London Cycling Campaign

December 2014

Consultation response on Transport for London plans for Deptford Broadway

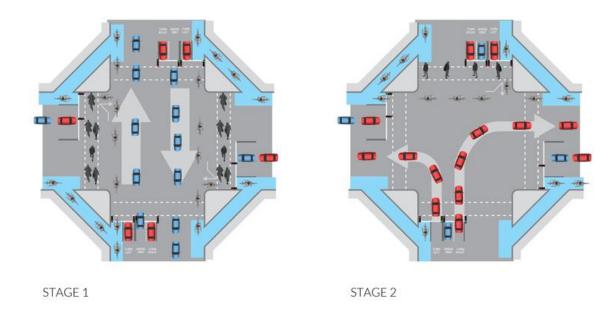
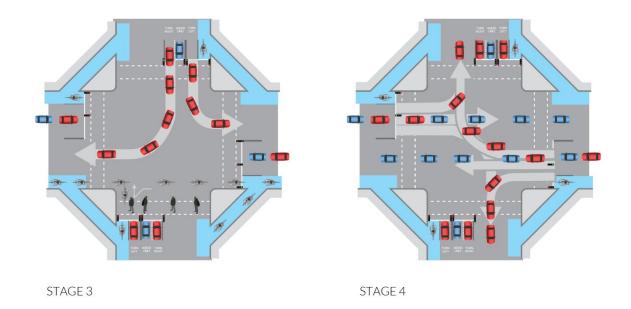
Below is a diagram and explanatory text which shows what is possible here. This figurative drawing illustrates a design which enables all cyclist and pedestrian movements through the junction to be fully protected and segregated from motor vehicle movements. We know elements of these more progressive ideas are already planned to be implemented at other junctions in South London e.g. Oval/Kennington. Transport for London has agreed previously that this model is capacity neutral.

On Stage 1, all north and south ahead traffic goes. At Stage 2, rights and lefts go together, and eastbound cyclists can go.

At Stage 3, southbound rights and lefts go together, and westbound cyclists go ahead. During Stages 2 and 3 east and westbound pedestrians can cross safely at the same time. At Stage 4, east and westbound traffic can go.

This model allows the same number of phases as currently, but gives more time for pedestrians and cycles to cross.
